ORIGINATION FORM

Proposed Revisions to a Standard Plans Index

Index Number: 102-607

Index Title:
Mobile Operations

SHEET
1 of 2

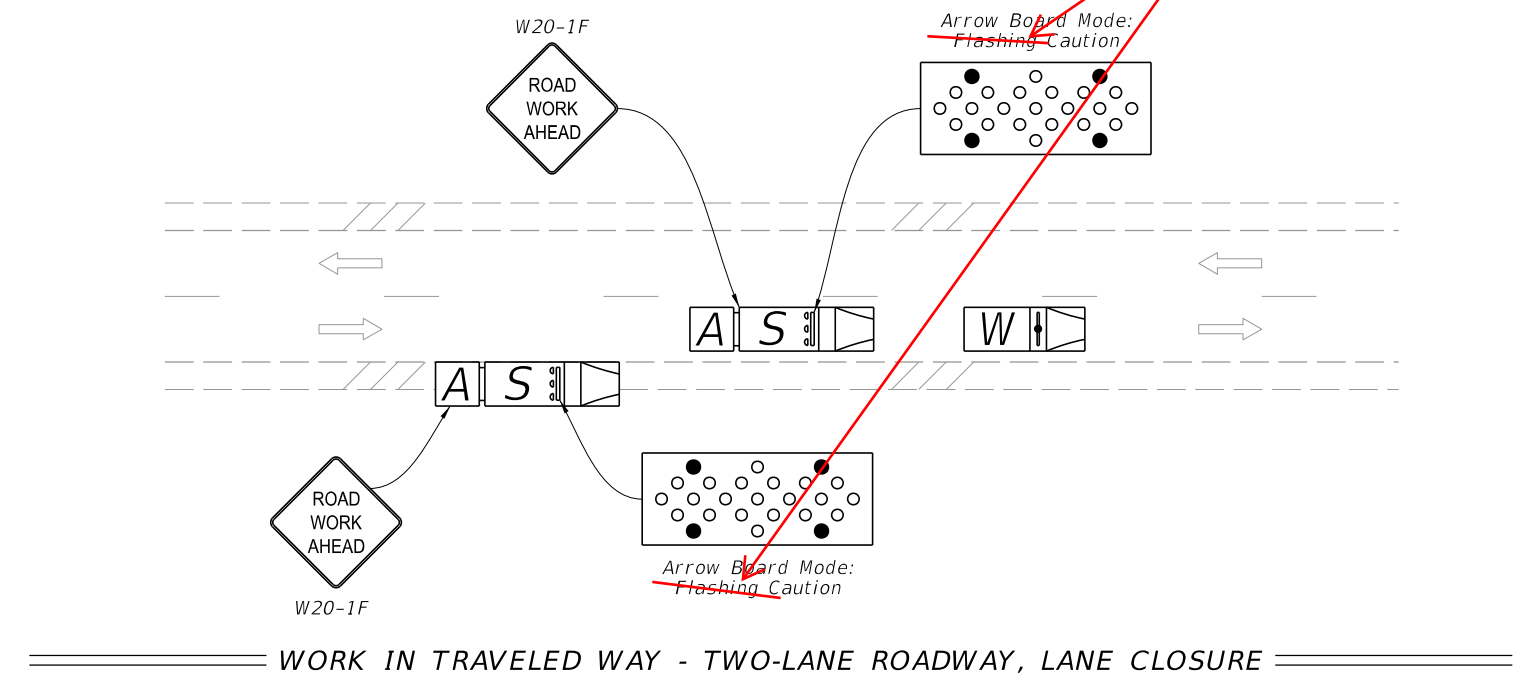
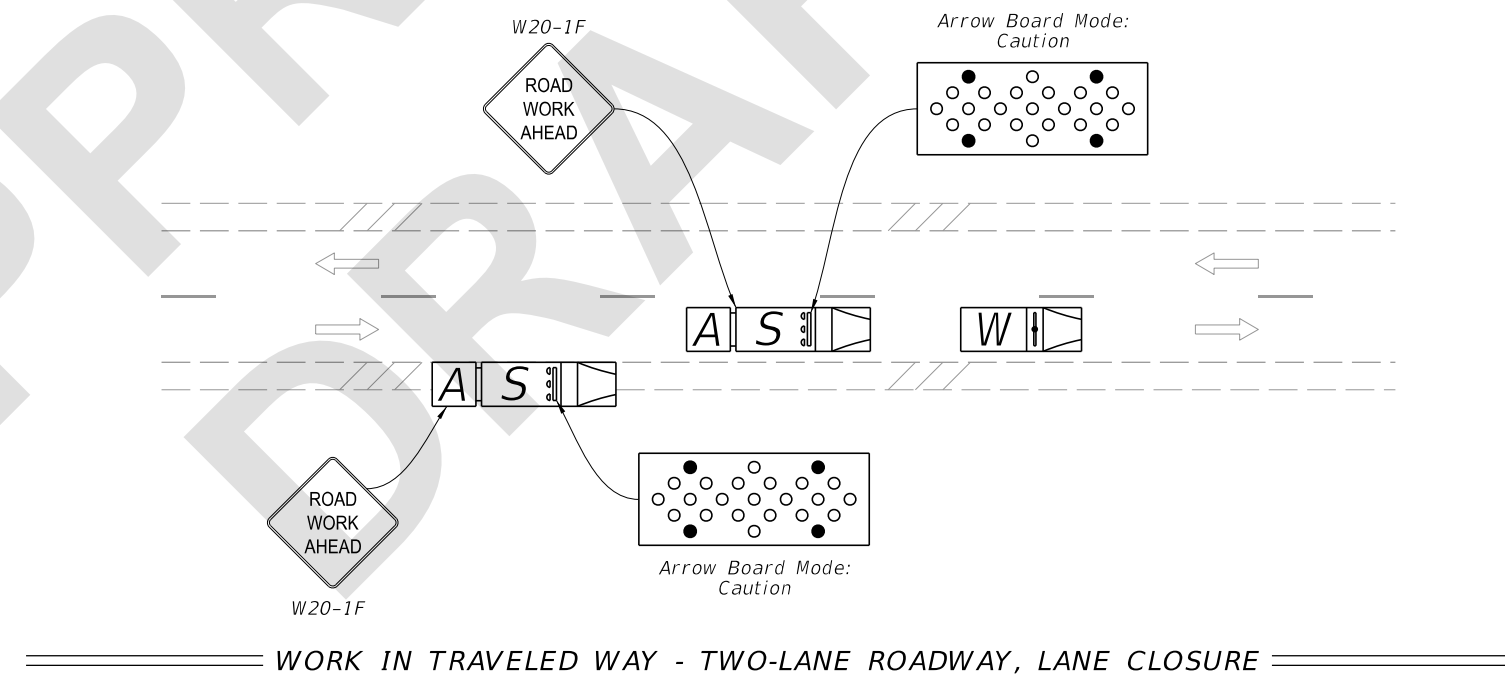
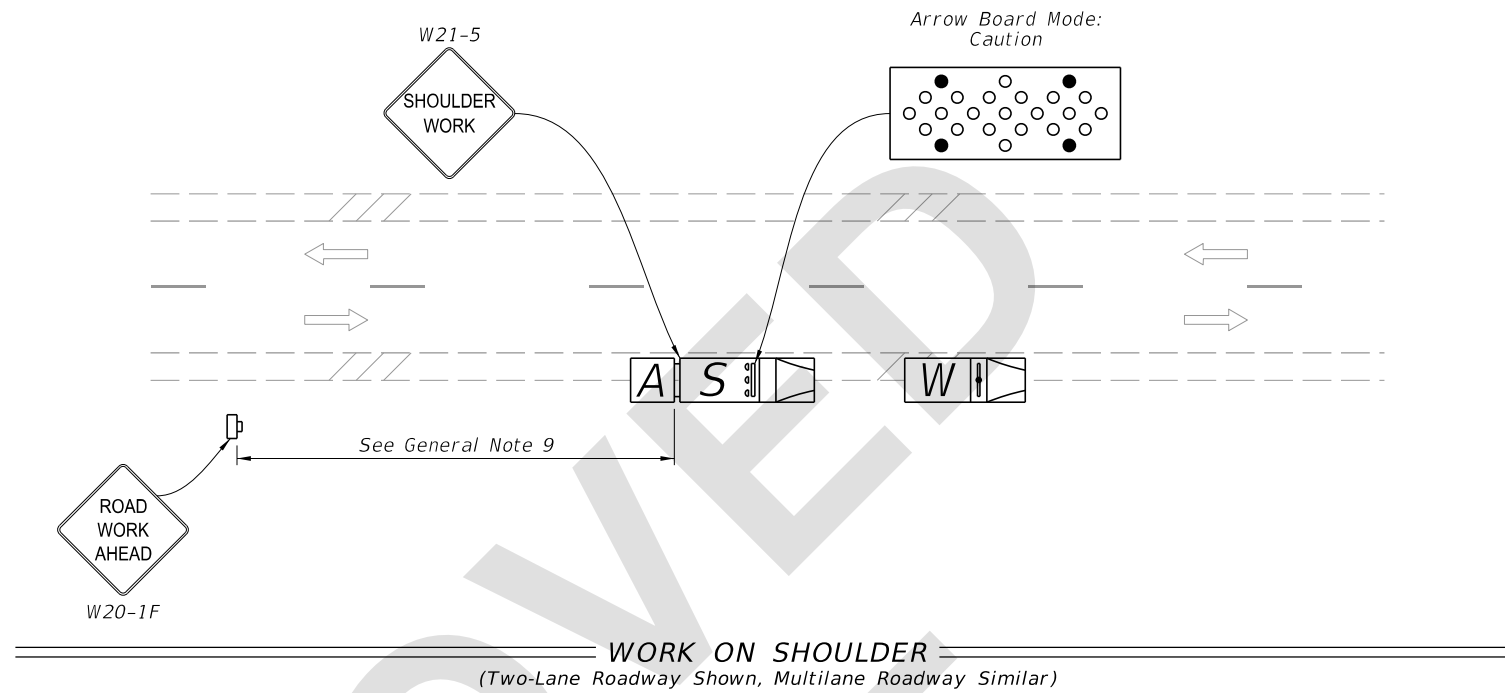
Sheet 1: Deleted "Flashing" from the Arrow Board Mode

DELETED: Flashing
